U.S. NUCLEAR REGULATORY COMMISSION

Docket/Report: 50-317/88-01  
50-318/88-01

Facility: Calvert Cliffs Nuclear Power Plant, Units 1 and 2

Summary: January 19-29, 1988: Combined Inspection Report Nos. 50-317/88-01  
and 50-318/88-01

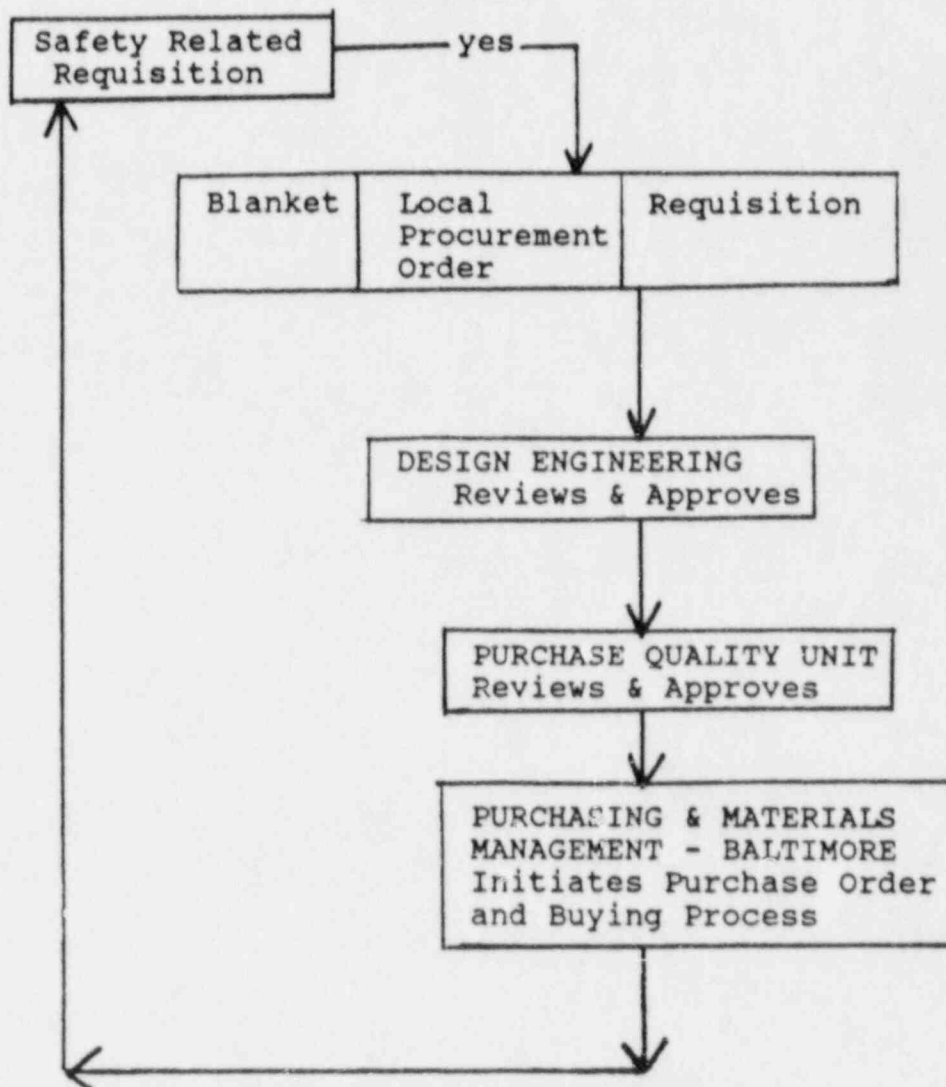
A feedback communication interface problem exists. The EPC does not communicate the status of the requisition to the PCCU. The PQU does not communicate the status of the requisition to the EPC or PCCU. The PCCU learns of the requisition status only after Baltimore cuts a purchase order. This process may take several weeks. (See diagram).
